**CITY OF EAST PROVIDENCE  
WATER MAIN CLEANING AND LINING PHASE V REBID  
RFP EP23/24-26R**

**ADDENDUM # 2 – OCTOBER 9, 2024**

The following revisions, clarifications, additions and/or deletions are hereby made a part of the Bid Documents for the City of East Providence's Water Main Cleaning and Lining Phase V Rebid project, RFP EP23/24-26R.

C2.2  
SHEET NO. 6 OF 26

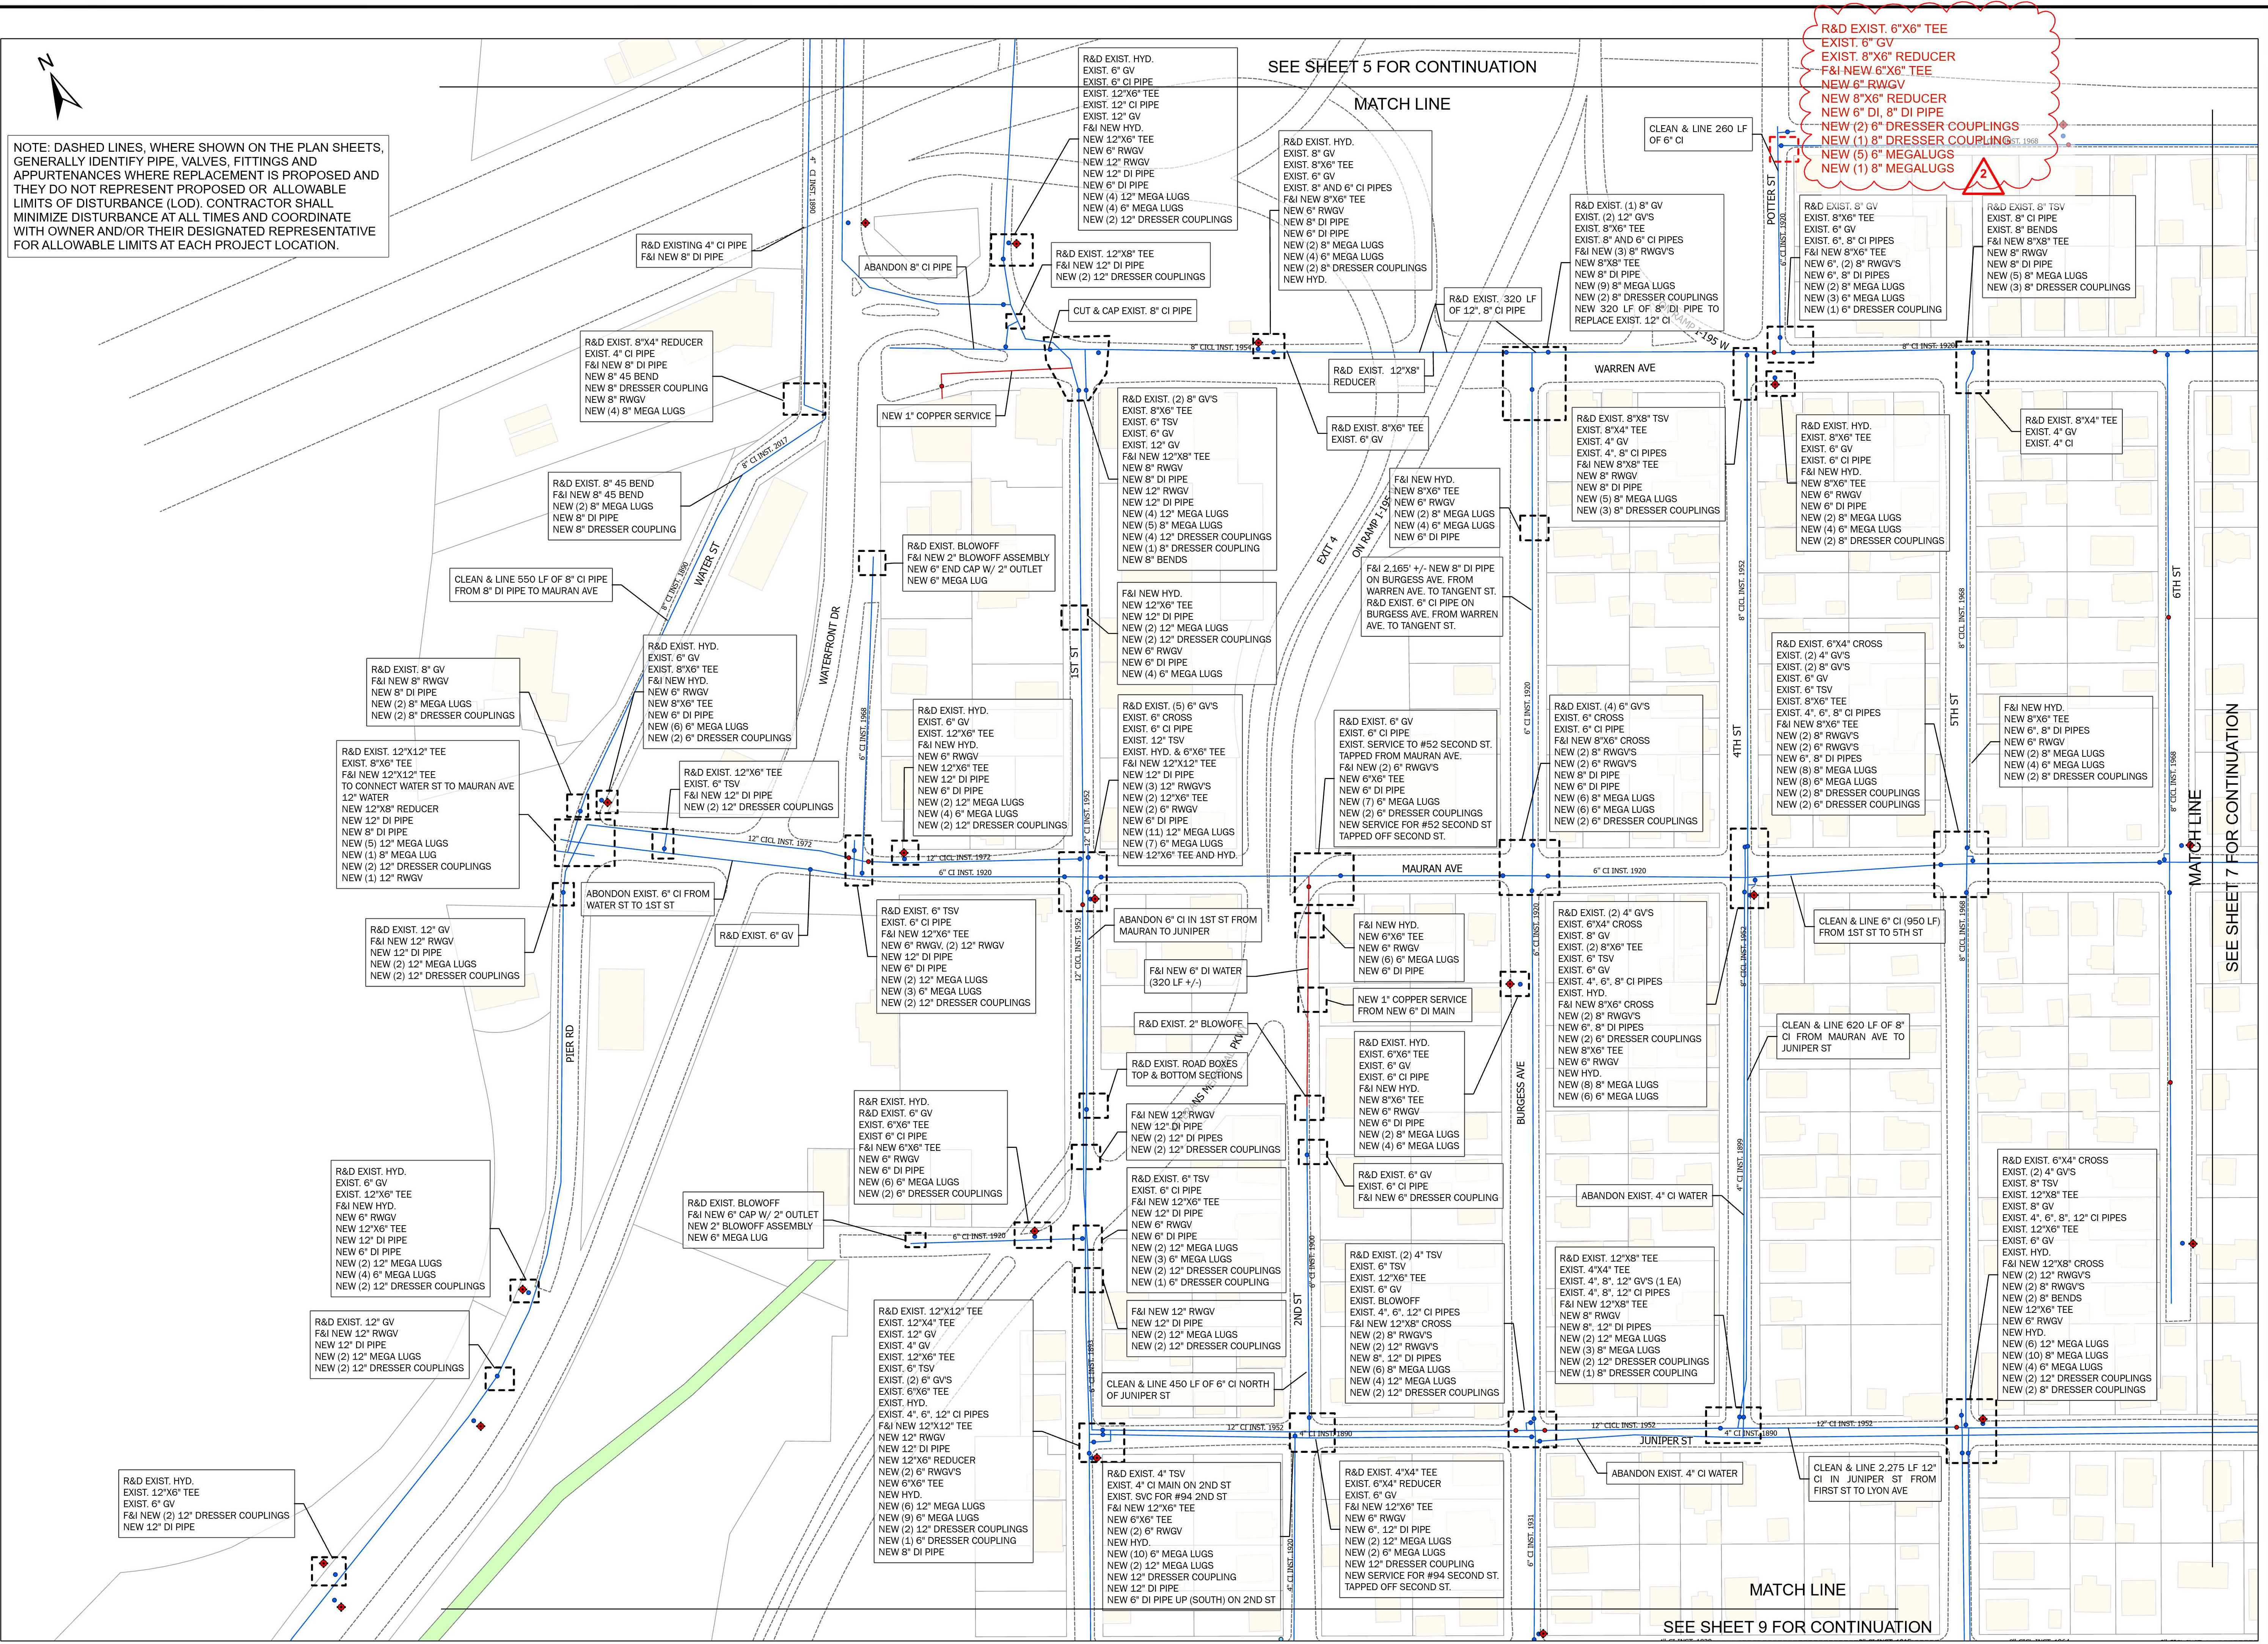
3. Sheet 6
  - a. On Potter St @ School St., what work is to be done there? Nothing is noted.
  - b. On Juniper St., we are to abandon the 4” CIP main. What services need to be transferred from the 4” to the 12”?
  - c. On 4<sup>th</sup> St, we are to abandon the 4” main. What services need to be transferred from the 4” to the 8”?
  - d. Does Pier Road & Water Front Drive Dead End?

**At Potter Street and School Street, the existing 6”x6” tee, 6” gate valve, and 8”x6” reducer are to be removed and replaced.**

**Information on service connections is on hardcopy tie cards. This information will be provided to the selected Contractor, but the City is unable to provide this information to bidders in a timely manner. Transfer of services will be paid using the various unit bid items included in the contract (e.g., corporation stops, service piping, etc.).**

SHEET NO. 7 OF 26

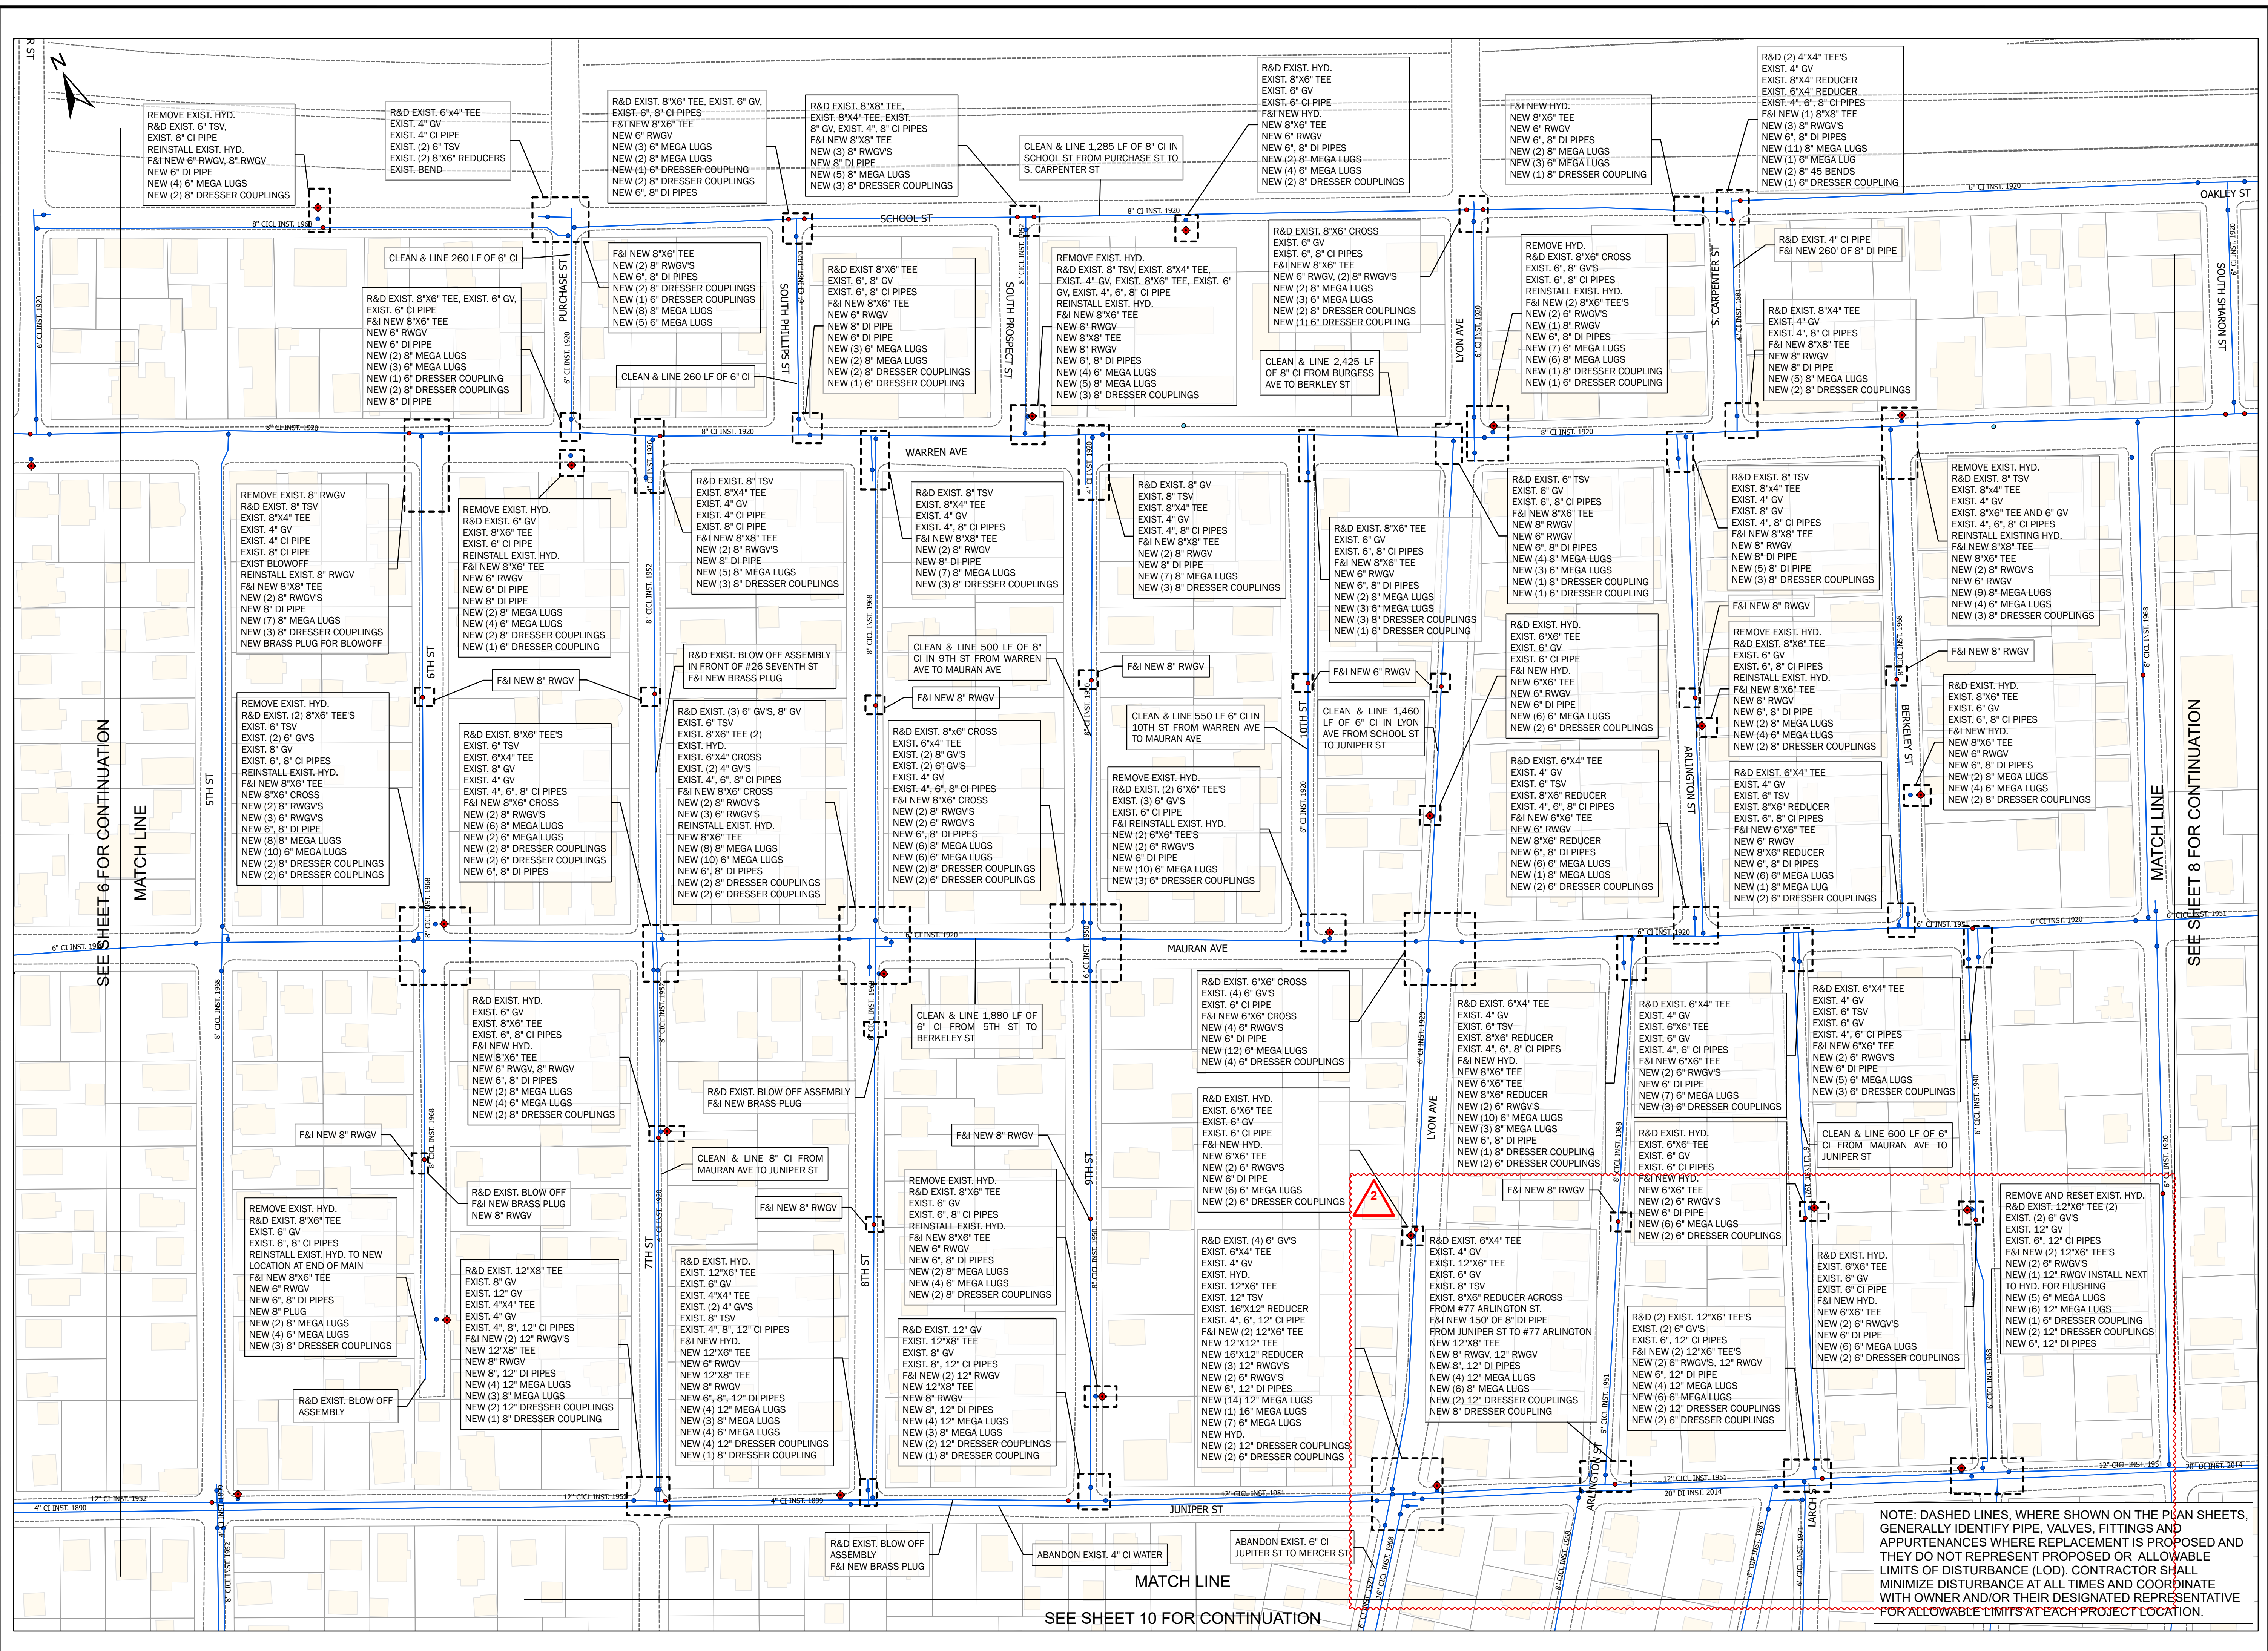
4. Sheet 7 – On Juniper St., we are to abandon the 4” CIP Main. Which services need to be transferred from the 4” to 12”?

**Refer to previous response regarding water service information.**

**Cleaning and lining of 6” water main in Juniper Street is no longer proposed. This pipe was previously removed, and a new 20” ductile iron transmission main installed, as part of a water supply improvement project in 2014/2015. No services need to be transferred to the 12” water main. Four 12” gate valves are now proposed in Juniper Street, between Follett & Ingraham. Drawing C2.3 (Sheet 7) and C2.4 (Sheet 8) have been revised as part of Addendum No. 2 and are attached.**
